BG&E Letter dated October 22, 1990

License Amendment Request

Low Temperature Overpressure Protection

PROPOSED TECHNICAL SPECIFICATION CHANGES

FIGURE 3.4-2b  
CALVERT CLIFFS UNIT 2 HEATUP CURVE, 12 EFY  
REACTOR COOLANT SYSTEM PRESSURE TEMPERATURE LIMITS

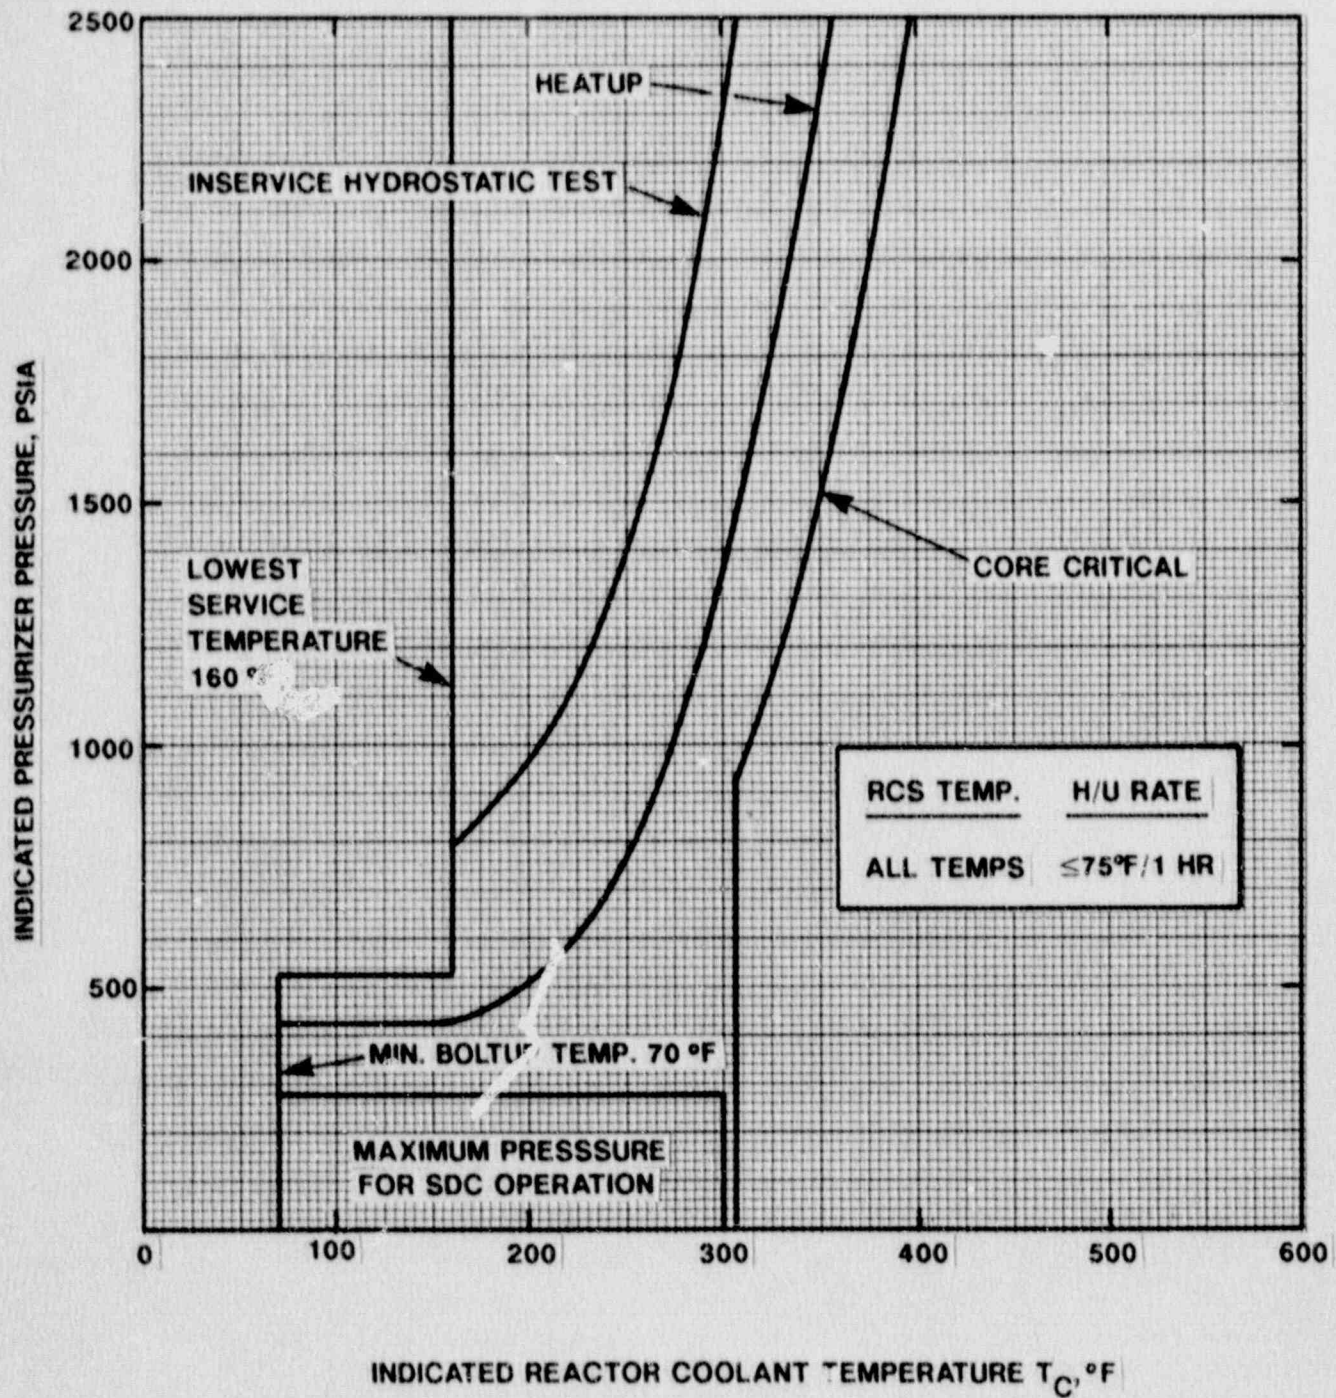
Both 10 CFR Part 50 Appendix G and ASME, Code Appendix G require the development of pressure-temperature limits which are applicable to inservice hydrostatic tests. The minimum temperature for the inservice hydrostatic test pressure can be determined by entering the curve at the test pressure (1.1 times normal operating pressure) and locating the corresponding temperature. This curve is shown for 12 EFPY on Figures 3.4-2b and 3.4-2c.

Similarly, 10 CFR Part 50 specifies that core critical limits be established based on material considerations. This limit is shown on the heatup curve, Figure 3.4-2b. Note that this limit does not consider the core reactivity safety analyses that actually control the temperature at which the core can be brought critical.

FIGURE 3.4-2c  
CALVERT CLIFFS UNIT 2 COOLDOWN CURVE, 12 EFY  
REACTOR COOLANT SYSTEM PRESSURE TEMPERATURE LIMITS

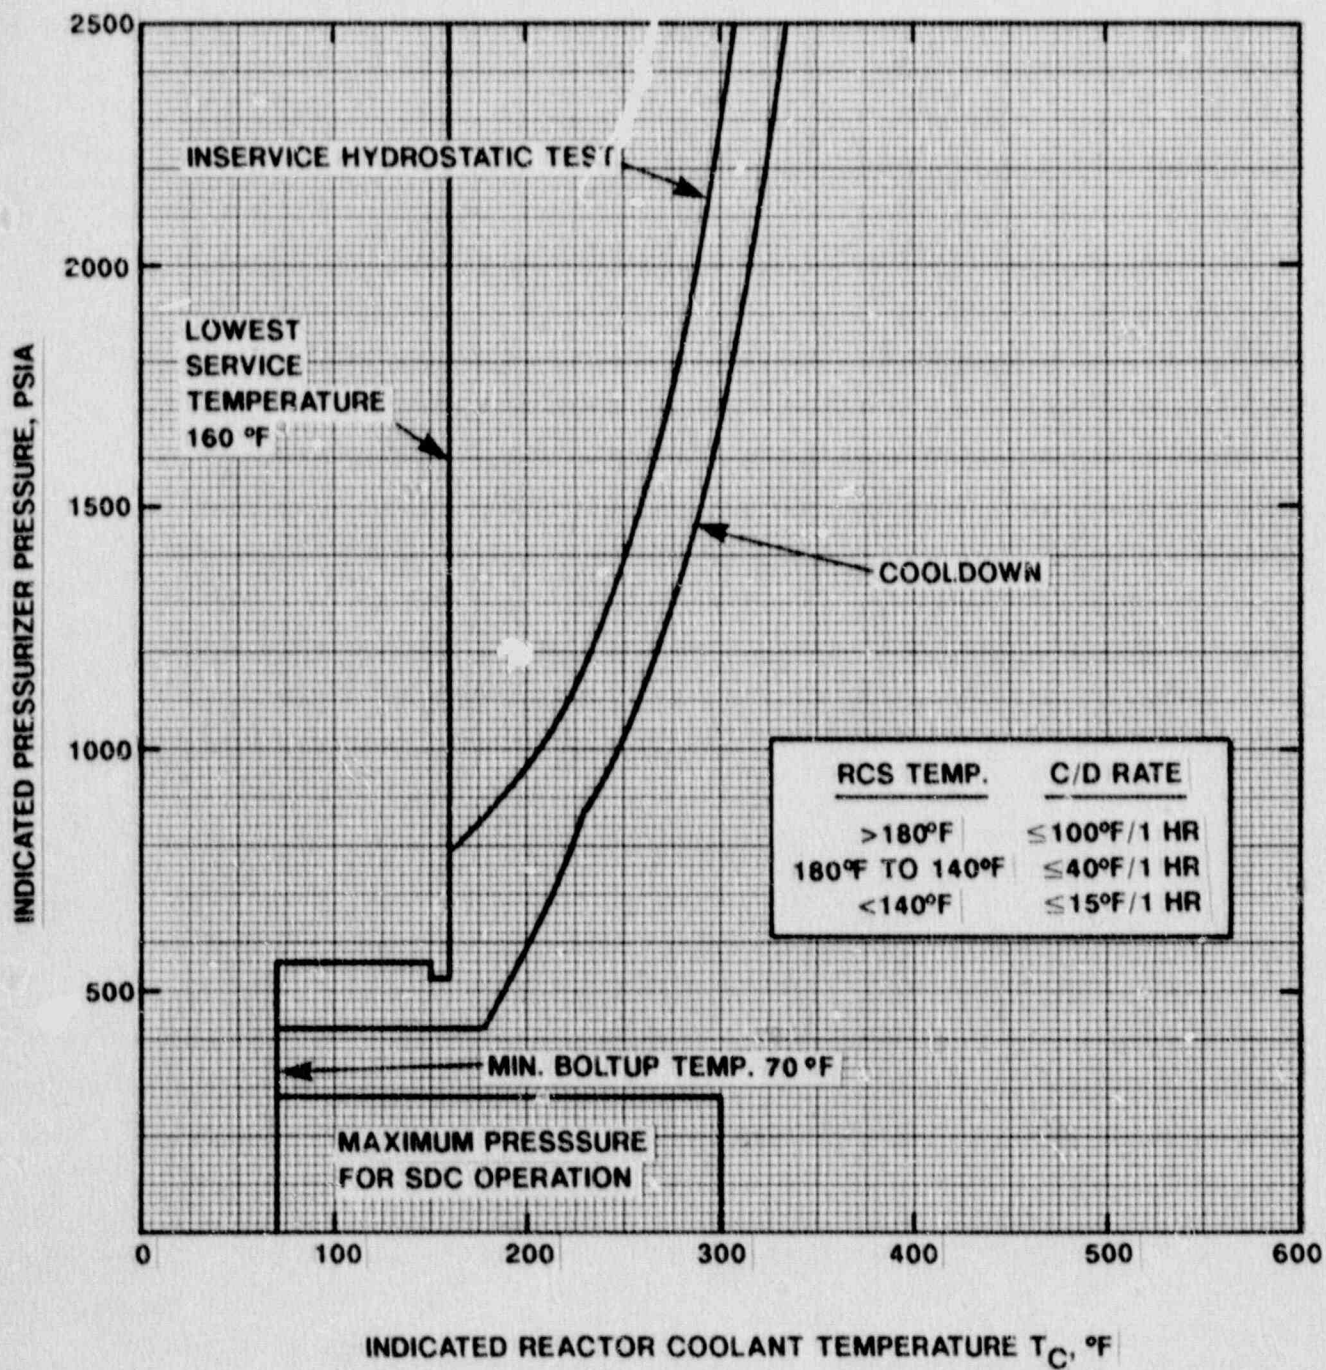
- 2. Verify the excessive flow condition did not raise pressure above the maximum allowable pressure for the given RCS temperature on Figure 3.4-2b or Figure 3.4-2c.
